PCN/23/012/C+N-US
Product Range: Han-Modular®

Title: Han® TC70 Contacts 2.5-16mm²

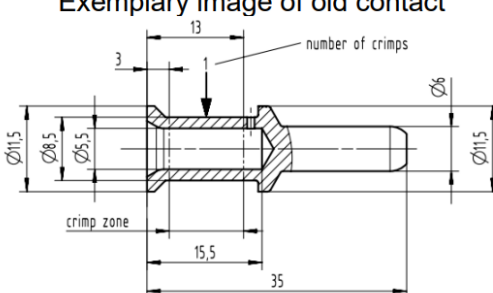
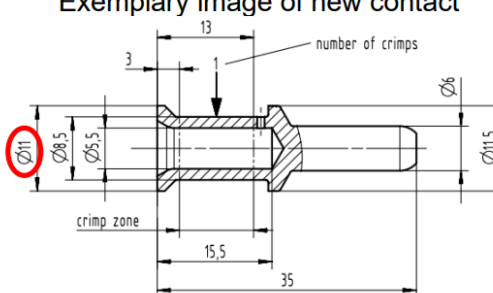
2. Description of Changes/News
<p>The outer diameter of the Han® TC70 contacts 2.5 – 16 mm² will be reduced from 11.5 mm to 11.0 mm on the termination side only.</p> <div style="display: flex; justify-content: space-around;"> <div style="text-align: center;"> <p>Exemplary image of old contact</p>  </div> <div style="text-align: center;"> <p>Exemplary image of new contact</p>  </div> </div> <p>The outer diameter 11.5 mm on the mating side and all other dimensions remain the same.</p>
